UNITED STATES  
DEPARTMENT OF THE INTERIOR  
BUREAU OF LAND MANAGEMENTFORM APPROVED  
OMB NO. 1004-0137  
Expires: January 31, 2018**SUNDRY NOTICES AND REPORTS ON WELLS**  
**Do not use this form for proposals to drill or to re-drill an**  
**abandoned well. Use form 3160-3 (APD) for such proposals.**5. Lease Serial No.  
NMNM113420

PISTOLERO 15 FED COM 603H

EOG Resources requests an amendment to our approved APD for this well to reflect a change in casing design as attached.

**Proposed Wellbore  
Revised 2/5/18  
API: 30-025-44325**

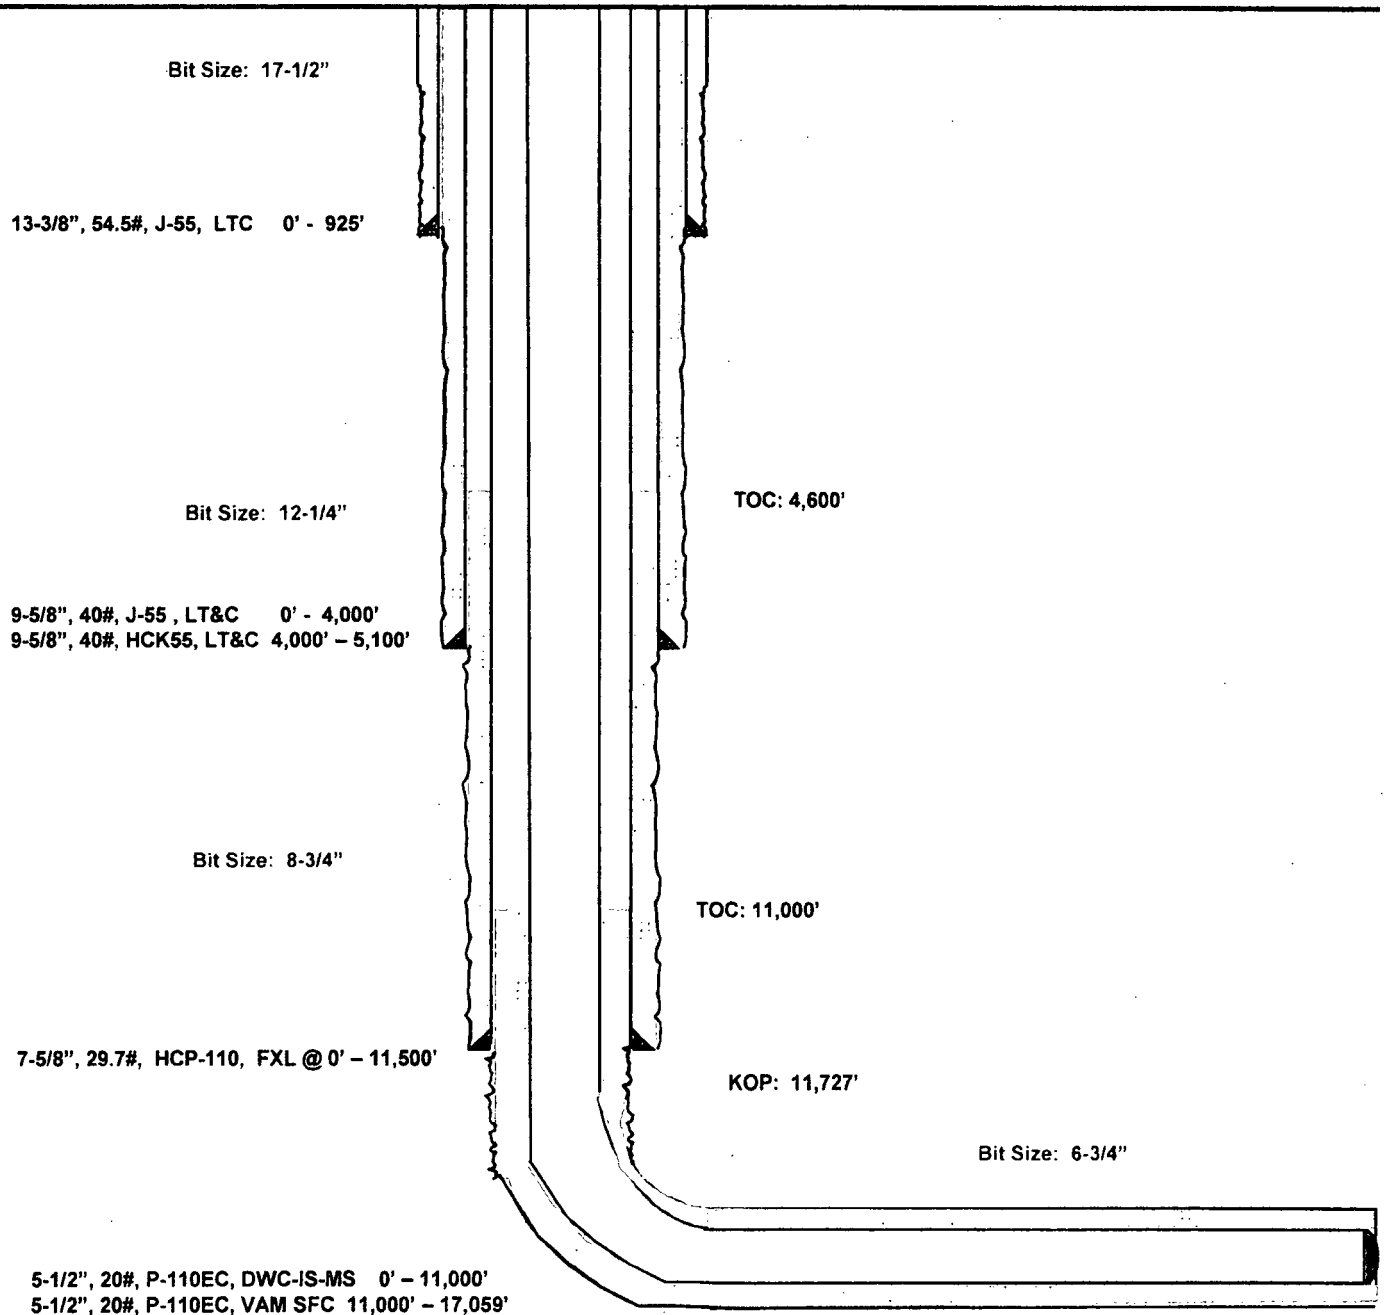
Change to 4-string casing design.

Variance is requested for annular clearance of the 5-1/2" x 7-5/8" to the top of cement.
